Drury Metropolitan Centre Fast-track

Auckland Council Specialist Memo

Healthy Waters & Flood Resilience

Healthy Waters & Flood Resilience Memo

Figure 2. Stormwater Management Devices and Areas (Figure 3. extracted from the Stormwater Assessment Report, Drury Centre – Version 4, dated 21 March 2025, prepared by Woods)

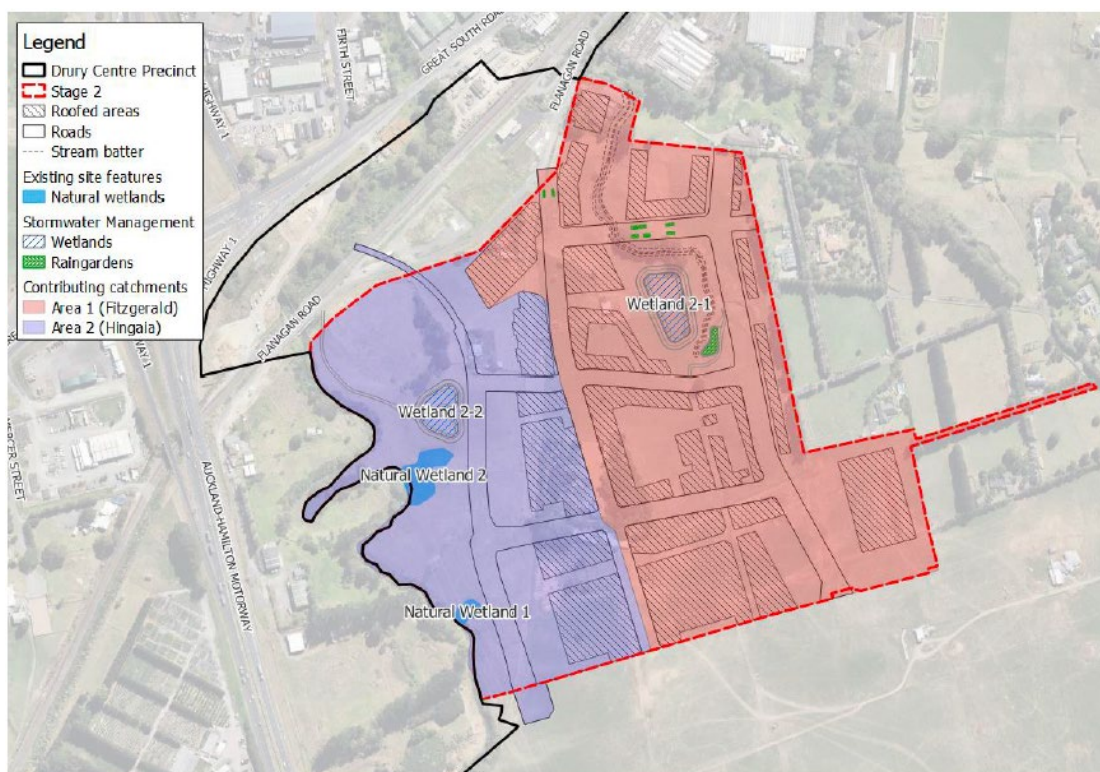
- 3.3. Stage 2 is divided into two sub catchments. Area 1 (shaded red within Figure 2) includes approximately 14.7ha which drains to this Fitzgerald Stream. Area 2 (shaded purple within Figure 2) includes 9.9ha which drains to the Hingaia Stream (Figure 2).

- 3.16. An indication of the existing Natural Wetlands and the proposed Stormwater Management Wetlands is included within Figure 2.
- 3.17. The proposed development will substantially increase both imperviousness and the total contributing catchment of Area 2 which discharges to existing Natural Wetland 2 and to the Hingaia Stream corridor downstream of the proposed rock chute. This change, along with increased imperviousness also proposed within Area 1, is expected to increase peak flows and poses a risk of erosion within the receiving environment.

- 3.37. The Application proposes two Stormwater Management Wetlands (Wetland 2-1 and Wetland 2-2) as shown within Figure 2. The Stormwater Management Wetlands are currently proposed to remain in private ownership, but are designed to receive stormwater from network that is proposed to be vested as public upstream.
- 3.38. In response to the S67 request for clarification on the proposed operation and maintenance responsibilities of the Stormwater Management Wetlands, the Applicant has confirmed that maintenance obligations will be secured via the stormwater discharge consent¹¹.

- 3.42. On review of the Application it appeared that Stormwater Management Wetland 2-2 may not have been sized to accommodate the entire contributing catchment area. Clarification regarding the sizing of the device was sought by HWFR as part of the S67 process.
- 3.43. In response to S67 request regarding the sizing of Stormwater Management Wetland 2-2, the Applicant has provided updated sizing calculations¹³. The revised sizing is considered acceptable for the purpose of this consent.

- The Applicant must either propose to vest Wetland 2-1 and Wetland 2-2 as public assets or confirm acceptance that any stormwater network upstream of the Stormwater Management Wetlands cannot be vested as public. If the Applicant prefers that the assets are vested as public, updated scheme plans must be provided indicating the Stormwater Management Wetlands (including maintenance access tracks) are located within '*Land in Lieu of Reserve – for Drainage Purposes*'.
- The Applicant must provide updated scheme plans that showing the public Communal Raingarden 2-1 (including maintenance access tracks) located within a '*Land in Lieu of Reserve – for Drainage Purposes*'.

Figure 3. Lot H2 - Level 00 - Floor Plan – DWG. H2-1302, date 07.03.2025, prepared by Ignite. Mark-up of Flanagan Road culvert location by HWFR (annotated)

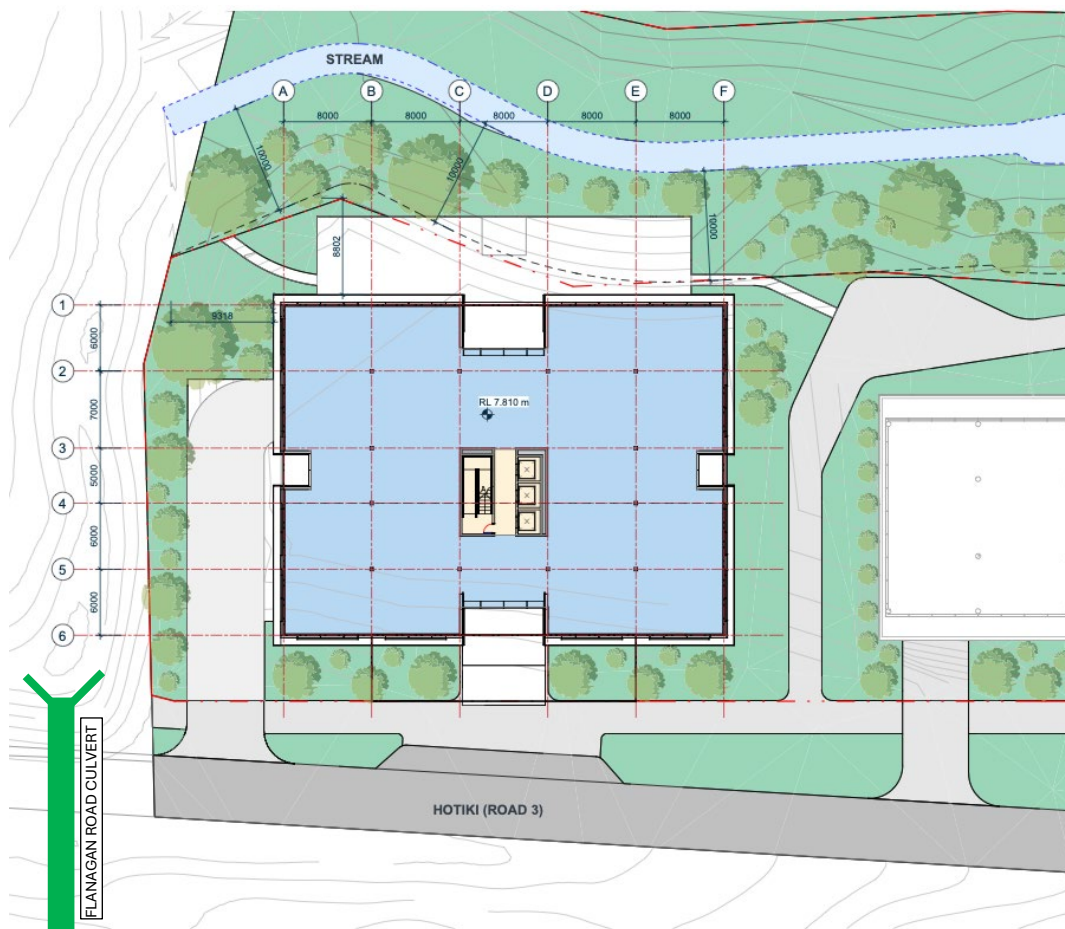
- 3.13. The development proposes earthworks within Lot 40 (Stage 2.10.2) to enable future development of Building H2 (Figure 3). The earthworks extend into the Fitzgerald Stream 10% and 1% AEP floodplains immediately adjacent to the existing public stormwater culvert under Flanagan Road. This culvert is over 50 years old and is considered critical public stormwater infrastructure for this catchment. A supplementary culvert has undergone public. Public consultation and is has been undertaken regarding this culvert with an upgrade planned for post 2040. The supplementary culvert is included in the Auckland Council Development Contributions Policy 2025 and is essential to enable the ultimate development of the upstream contributing catchment in accordance with the Drury Centre and Drury East SMP. The upgrade of this culvert is critical to provide flood resilience to the wider area, and in particular the area immediately upstream of the culvert including Drury Centre Stage 2 and Drury Rail Station.

- 3.14. The proposed development of Lot 40, including Building H2 and ancillary hardstand areas, presents a significant risk to the practicability of the Flanagan Road Culvert upgrade. This is

due to the proximity of the proposed building and infrastructure being offset by less than 10m from the top of stream bank. To enable adequate space for the Flanagan Road Culvert upgrade, HWFR recommends that the extent of proposed development within Lot 40 is amended so that a minimum of 20m offset is provided from the top of bank of the stream to the edge of any building or infrastructure.

- 3.15. Due to the nature of progressive urban, commercial, and industrial development of the Flanagan Road Culvert catchment, including the proposed LFR development, the risk of blockage to the culvert will increase. HWFR holds several records and evidence of culverts blocking during the flooding events across the Auckland Region (refer Figure 4). This includes both small and large culverts. In the event of blockage, flooding behind the culvert could rise up to a minimum 9.6mRL. The proposed FFL for Building H2 is 7.8mRL (with basement carparking proposed at 4.6mRL). On this basis, the risk of flooding to building H2 is considered significant.

- 3.30. Erosion is also occurring along the Fitzgerald Road Stream. Building H2 and Lot J are proposed to be located relatively close to the Fitzgerald Stream (Figure 3). It has not yet been determined that stream erosion will not undermine the proposed Building, and that the Building will ultimately comply with the Building Code's required structural lifespan of 50-100 years.

- 3.31. Consent has been sought for an infringement of the 10m riparian yard for Stream A with respect to a corner of Building H2⁸. The Architecture Plans indicate that the driveway for building H2 is located within the riparian yard of the section of stream at the outlet of the Flanagan Road Culvert (Figure 3). It appears that consent has not been sought for this infringement, including for imperviousness that may exceed 10%. Broader concern with the proposed location of this building and driveway are outlined in Section 3.13 and 3.14.

- The Applicant must provide revised development layout for Lot 40 that provides a minimum of 20m of 'green space' offset from the Flanagan Road Culvert to any buildings or infrastructure (including access roads or driveways).

- The Applicant must assess the risk of flooding to proposed buildings and infrastructure adjacent to Fitzgerald stream from potential blockages of Flanagan Road culvert.

- The Applicant must provide an erosion assessment of the Fitzgerald Stream to understand the potential migration of the stream overtime and demonstrate this will not undermine the proposed structures adjacent to the stream.

Figure 5. Drury Centre Stage 2, Proposed Roding Plan (Sheet 1 of 4) – DWG. P24-447-01-2001-DR, Revision 7, dated 21.02.2025, prepared by Woods

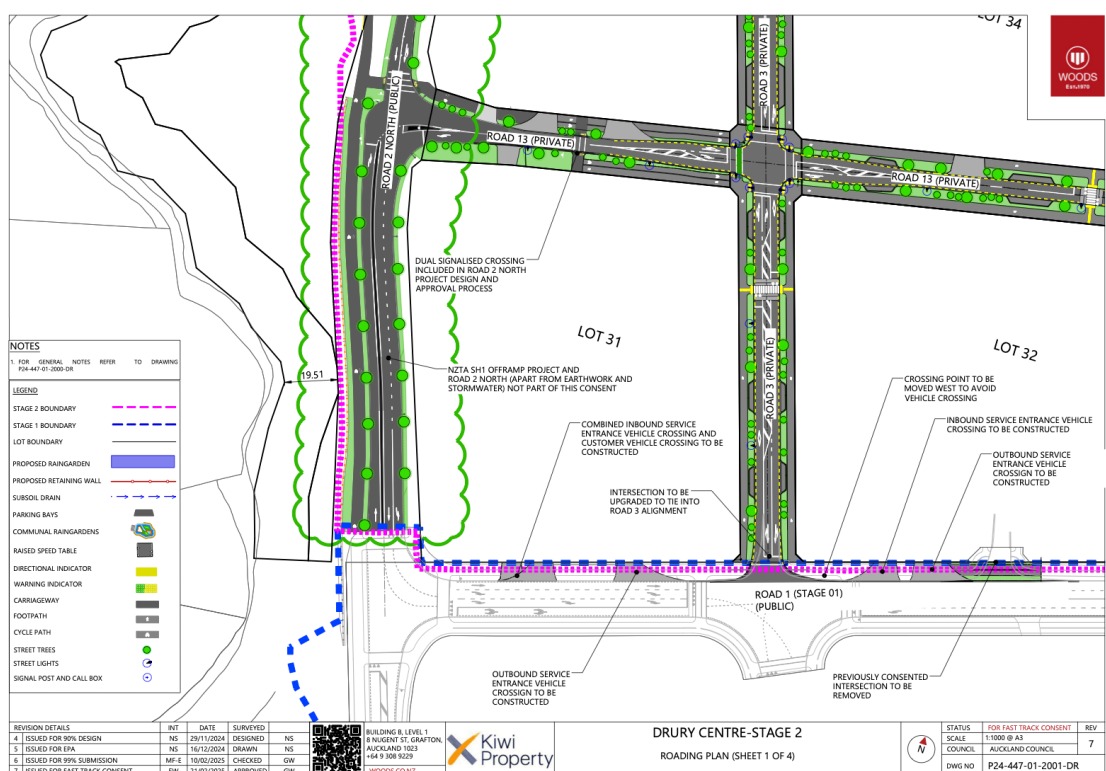
- 3.28. As noted above, Hingaia Stream is actively eroding in the vicinity of the proposed development. Figure 5 indicates that there is only 19.5m between the proposed road and the Stream. An outer bend of the stream is located adjacent to the proposed road. This bend will be subject to increased erosive forces which will increase the potential erosion risk to the road.
- 3.29. It has not yet been demonstrated that the proposed road will remain stable long term, and will ultimately comply with the Building Code's required structural lifespan of 50-100 years. HWFR recommends that a Geomorphic Risk Assessment is undertaken to assess and understand long term erosion risk. The outcomes of this Assessment should inform appropriate structural design or the implementation of suitable mitigation measures.

- The Applicant must carry out a Geomorphic Risk Assessment of the Hingaia Stream, adjacent to the proposed development in order to understand long term erosion risk. The outputs of the Geomorphic Risk Assessment can be used to ensure that the proposed assets and structures adjacent to the stream are designed appropriately and will not be undermined by ongoing stream erosion.
